August 24, 2015
RC-15-0125

Subject: VIRGIL C. SUMMER NUCLEAR STATION (VCSNS), UNIT 1
DOCKET NO. 50-395
OPERATING LICENSE NO. NPF-12
FIFTH SIX-MONTH STATUS REPORT IN RESPONSE TO MARCH 12, 2012,
COMMISSION ORDER MODIFYING LICENSES WITH REGARD TO
REQUIREMENTS FOR MITIGATION STRATEGIES FOR BEYOND-DESIGN-
BASIS EXTERNAL EVENTS (ORDER NUMBER EA-12-049)

**FIFTH SIX-MONTH STATUS REPORT FOR THE IMPLEMENTATION OF ORDER
MODIFYING LICENSES WITH REGARD TO REQUIREMENTS FOR MITIGATION
STRATEGIES FOR BEYOND-DESIGN-BASIS EXTERNAL EVENTS
(ORDER EA-12-049)**

Figure 4 – Conceptual Strategy for Reactor Makeup and Reactivity Control

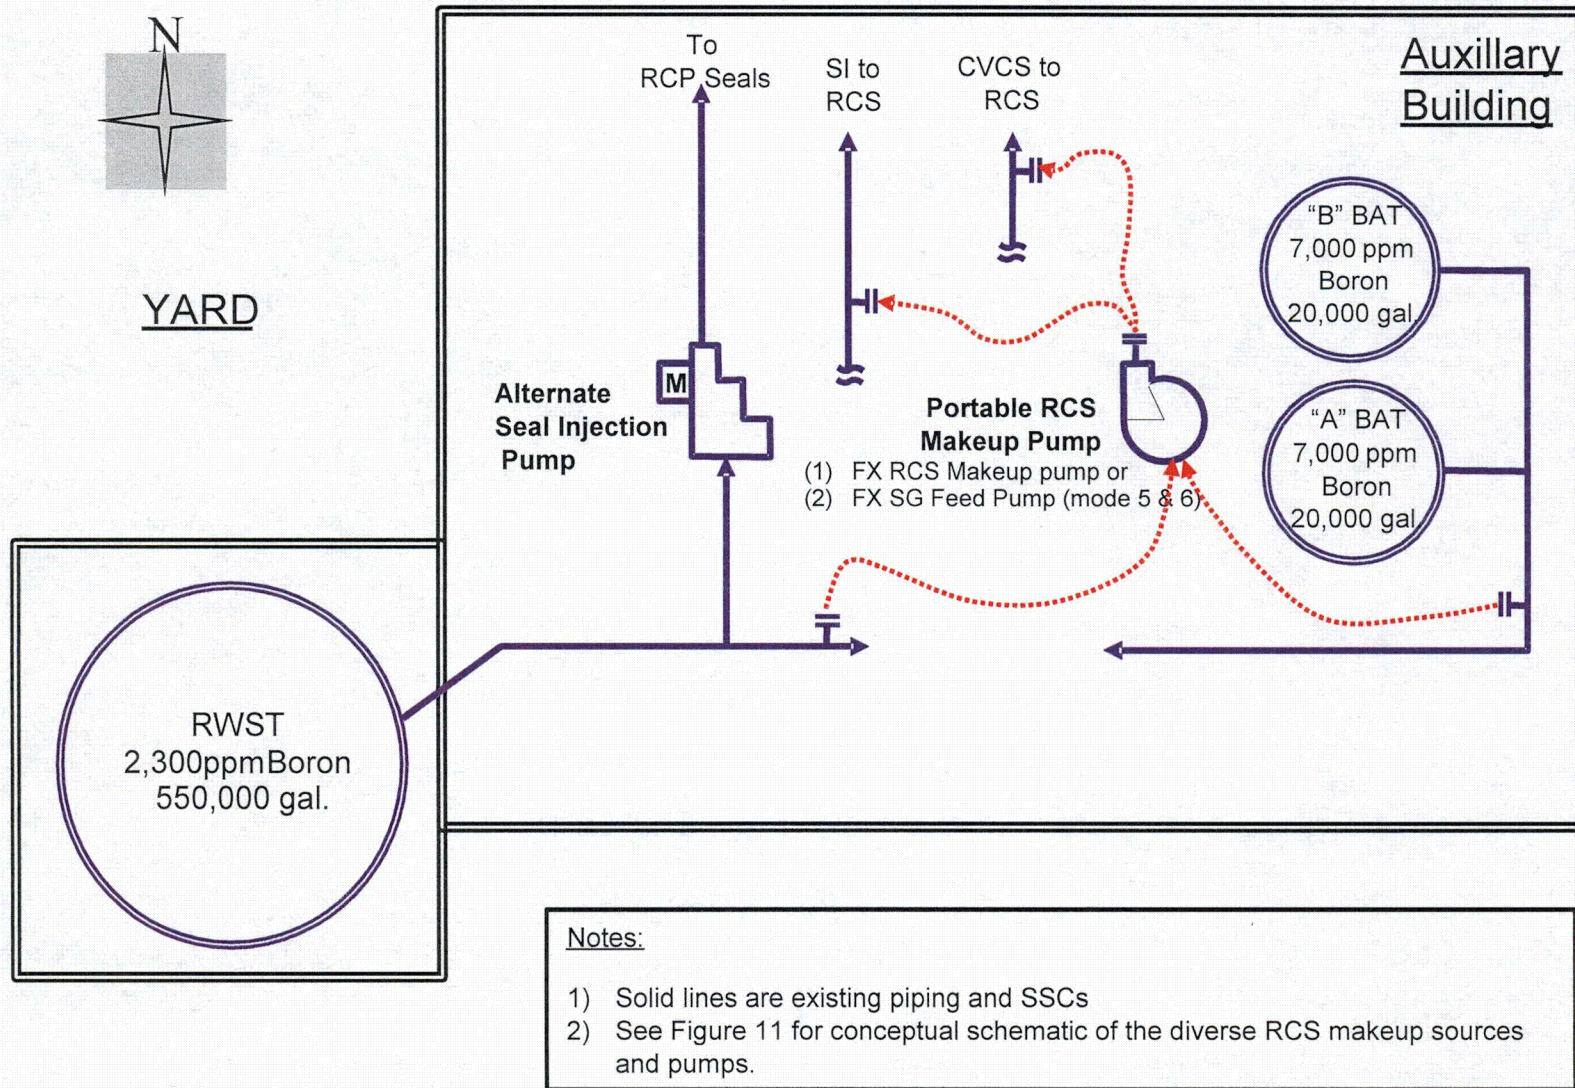
4. Change: The strategy for Reactor Coolant System (RCS) inventory and reactivity control, Phase 2, included use of the station's installed Alternate Seal Injection (ASI) pump and a portable FLEX RCS Makeup Pump (FX RCS MU PUMP). The strategy has been changed to credit two FX RCS MU PUMPS.

5. Change: The strategy for RCS inventory and reactivity control, Phase 3, has been modified to include a mobile boration skid. The skid will be provided by the National SAFER Response Center (NSRC).

8. Change: The following figures have been revised to reflect current strategies. The updated figures are provided within Attachment 2 of this report.

Figure 5 – Conceptual Coping Strategies for Support Functions from EB

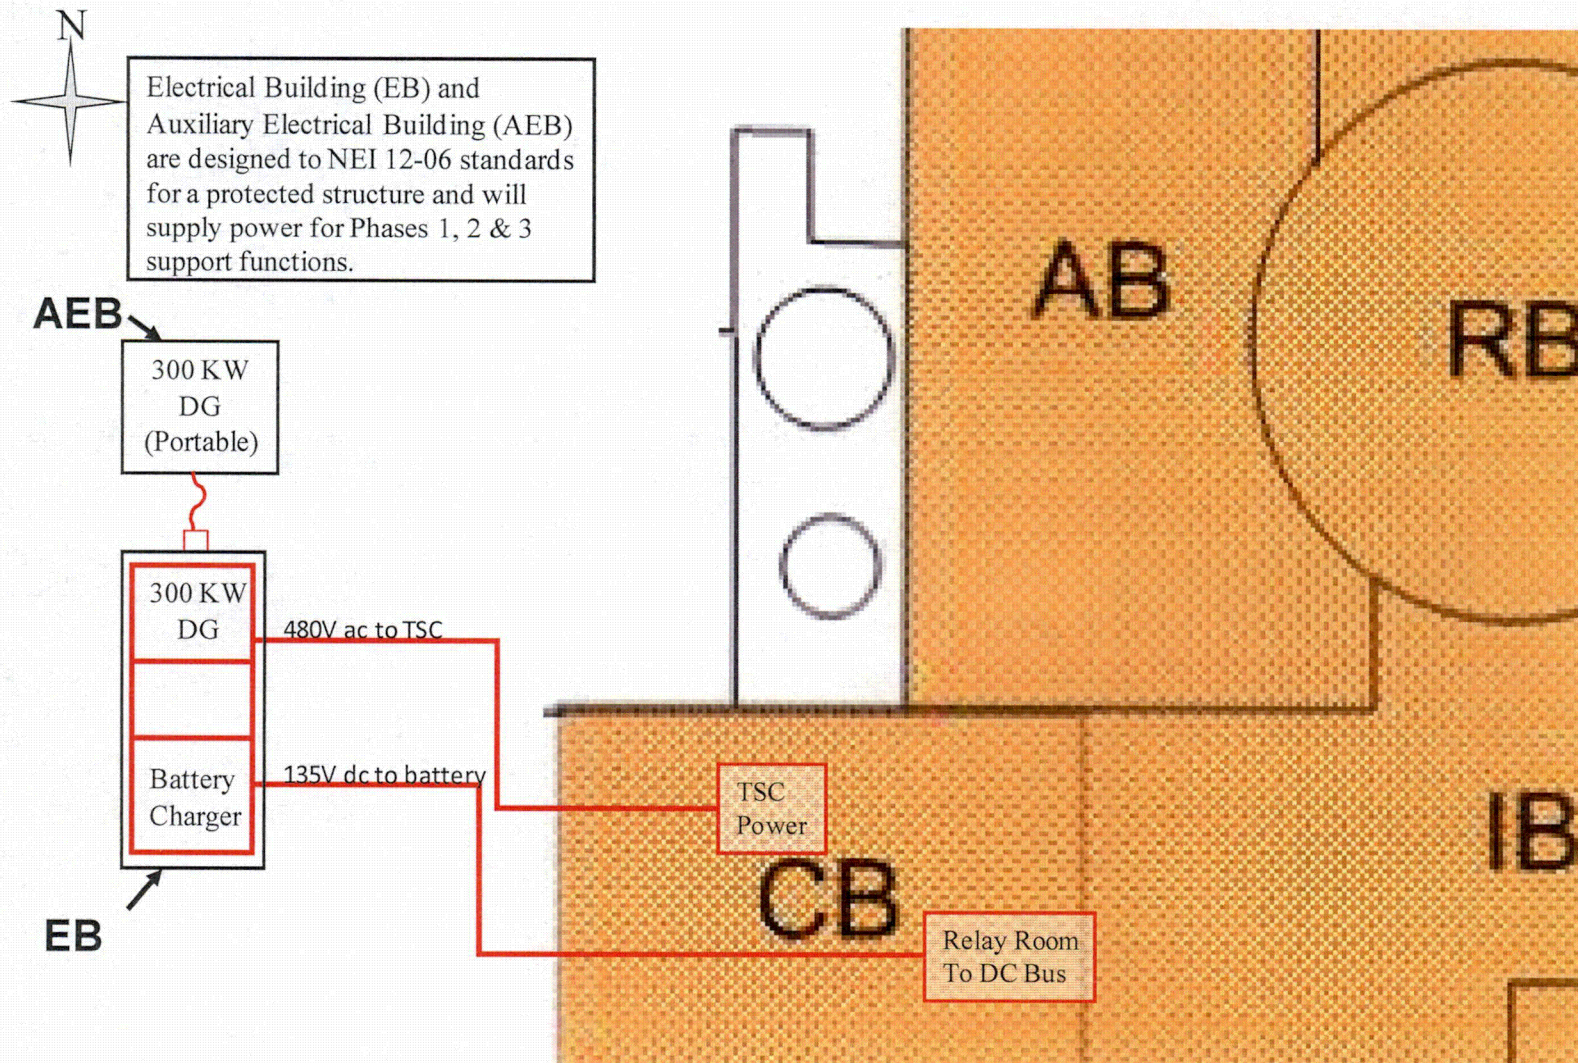
7. Change: Two methods for extending DC power availability, Phase 2, are being added to the Safety Function Support strategies. These methods will utilize B5b equipment. One method uses a portable 80kW generator and AC distribution panel to supply AC power to the input of the Station Battery Chargers. The second method uses a portable 80kW generator and a portable battery charger to supply DC power to the output of the station battery chargers. The equipment for one method will be stored in the ERB and the equipment for the other method will be stored in the FSB.

Figure 7 – Conceptual Strategy for Supplying SG Makeup Using Alternate EFW Suction

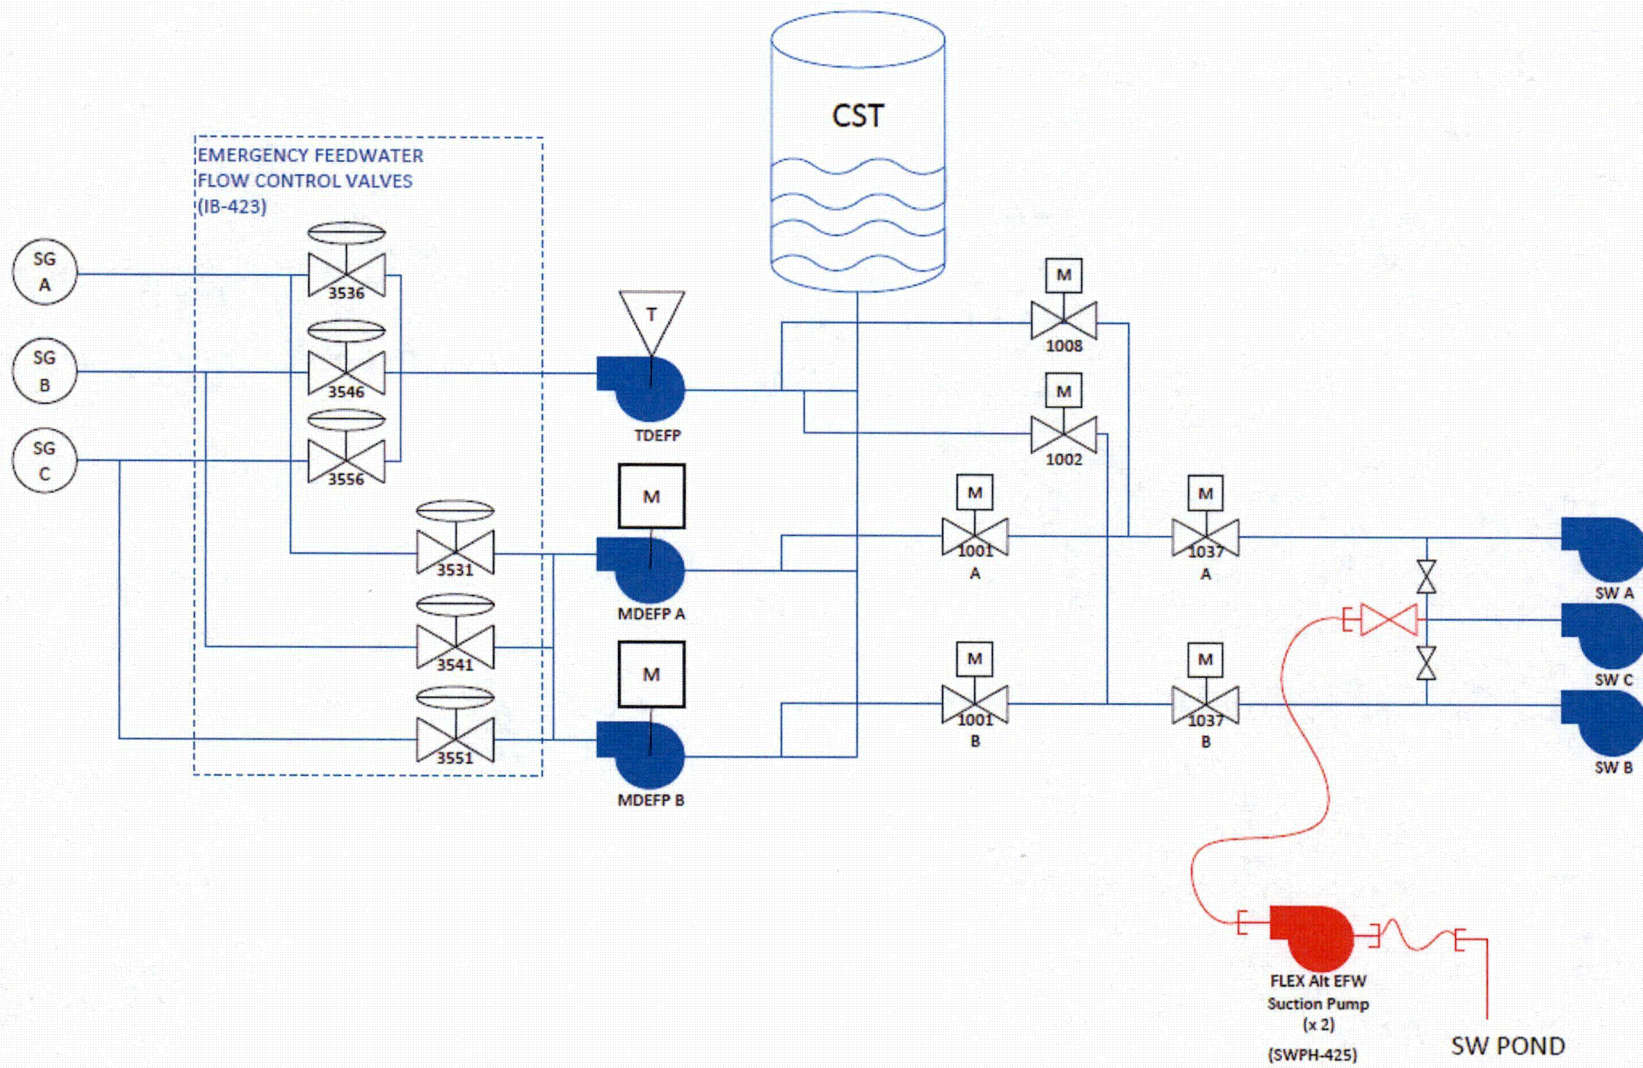
2. Change: In order to maintain core cooling during Phase 2, the primary strategy is being modified to include an alternate suction source for the Emergency Feed Water (EFW) pumps in the event the minimum Condensate Storage Tank (CST) inventory is not immediately available. A FLEX Alternate EFW Suction Pump will transfer water from the Ultimate Heat Sink (UHS) to the 'C' Service Water (SW) Pump header to allow alignment to any EFW pump via the design basis SW to EFW flow path.

Justification: The CST does not meet the hazard protection requirements concerning high winds from tornados documented in NEI 12-06, *Diverse and Flexible Coping Strategies (FLEX) Implementation Guide*, Revision 0. Therefore, the CST is not creditable for FLEX. This change will ensure a strategy exists to cope with all applicable beyond-design-basis external events (BDBEE).
